Palo Verde Nuclear
Generating Station

**Subject: Palo Verde Nuclear Generating Station (PVNGS)
Unit 3
Docket No. STN 50-530
Response To Request for Additional Information
Regarding Lead Fuel Assemblies-Exemption Request**

**NRC Request for Additional Information
PVNGS Unit 3 Exemption Request**

Figure 4.2-10

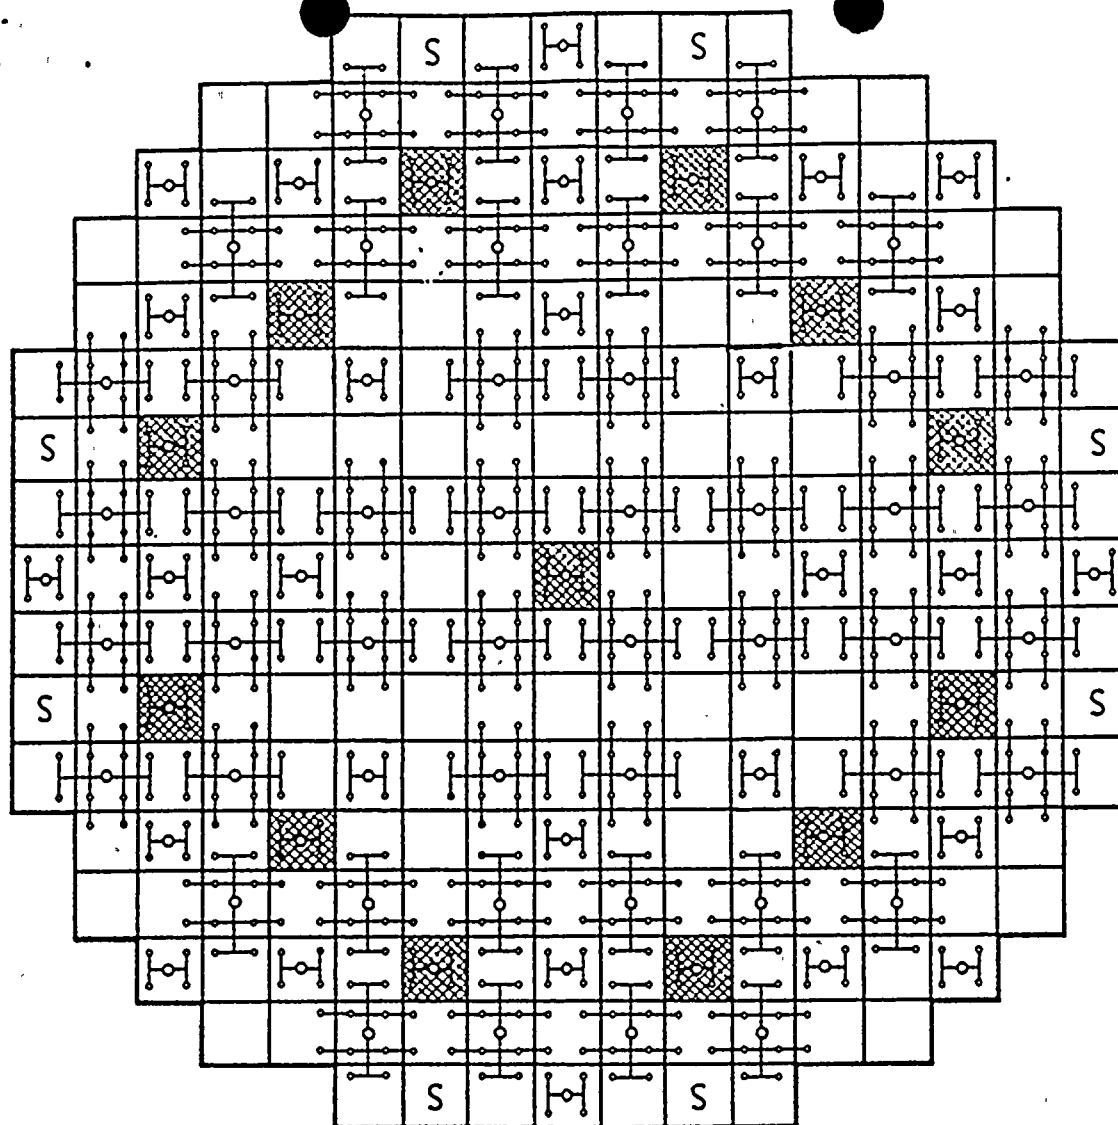
1. Are the test assemblies in rodged locations?

Yes. The two new test assemblies will be located under 2 rods from Group 1 and 2 rods from Shutdown Bank A. The Batch F carrier assembly with the 10 test rods will be under 4 part-length rods from Part Length Group 1. These rods are depicted in PVNGS UFSAR drawing 4.2-10, "Control Element Assembly Locations," (copy attached).
